ACCESS REPORT

Proposed residential apartment building
35-39 Darley St East, Mona Vale NSW

Reference No.
26011-DA

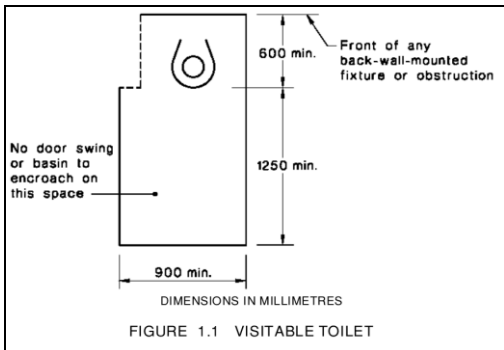
ACCESSIBLE ENTRY		
The entry to the dwelling shall be accessible	4.3.1	The entry to all dwellings is noted to be accessible.
The required landing for the entry door shall be graded not steeper than 1:40.	4.3.1	Compliance with this clause has been demonstrated.
The landing for the entry door shall comply with AS 1428.1-2009 in respect to required circulation space.	4.3.2	Compliance with this clause has been demonstrated.

ADAPTABLE HOUSE CLASS C		
Requirement	Clause No.	Assessment commentary
The entry door to the dwelling shall achieve a minimum of 850mm clear opening (i.e. 920mm door leaf).	4.3.2	Compliance with this clause is readily achievable at the CC design stage.
The entry door shall have hardware as follows: a. Capable of being opened with one hand as per AS 1428.1; and b. Installed between 900-1100mm above the finished floor.	4.3.4	Compliance with this clause is readily achievable at the CC design stage.
INTERIOR: GENERAL		
All internal doors must achieve a clear door opening width of not less than 820mm (850mm preferred).	4.3.3	Compliance with this clause is readily achievable at the CC design stage.
Internal corridors to be minimum width of 1m.	4.3.7	Compliance with this clause is readily achievable at the CC design stage.
Provisions required for all doorways within the dwelling to achieve the prescribed circulation space in AS 1428.1.	4.3.7	Compliance with this clause has not been demonstrated in particular for the secondary bedrooms and balcony doors in the adaptable unit layouts. Design to be revised to comply at the CC stage.
